To: City of the Village of Douglas Planning Commission

Date: July 5, 2024

From: Sean Homyen, Planning & Zoning Administrator

RE: 319 Ferry St – Proposed Multi-Family Development

Figure 3 – New Site Configuration and Shared Parking Easement Areas

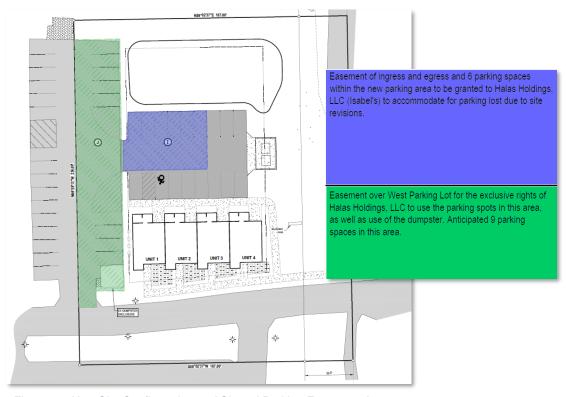
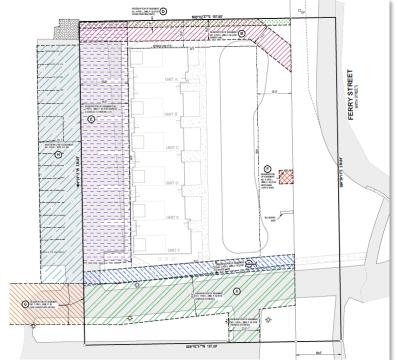
4. Easements – Shared Parking: At the April 11 meeting, the Planning Commission received written communication from representatives of Isabel's indicating that the applicant does not have the right to remove the parking spaces on the subject parcel, as they are part of a shared parking agreement, and were required as part an expansion that was approved for the Isabel's parcel. The applicant was made aware that the issue with the shared parking agreement was a private matter between property owners that must be resolved prior to the project being placed on a future Planning Commission agenda.

parking area is proposed to account for the shared spaces that would be lost due to the development of the site. The new shared parking easement configuration is shown in Figure 3 below. The previous site configuration with easement exhibit is shown in Figure 4 for comparison.

Update: The applicant has proposed an entirely revised configuration of the site to address the concerns expressed by the neighboring property owner related to the subject parking spaces. The reconfigured site proposes the single 4-unit building facing the access drive from Ferry Street, removal of attached garages, and a parking area immediately behind the building to the south. A portion of the parking spaces within the

It was indicated by the applicant that the Isabel's property owners are amenable to this solution. Easement agreements will need to be drafted and signed by all applicable parties.
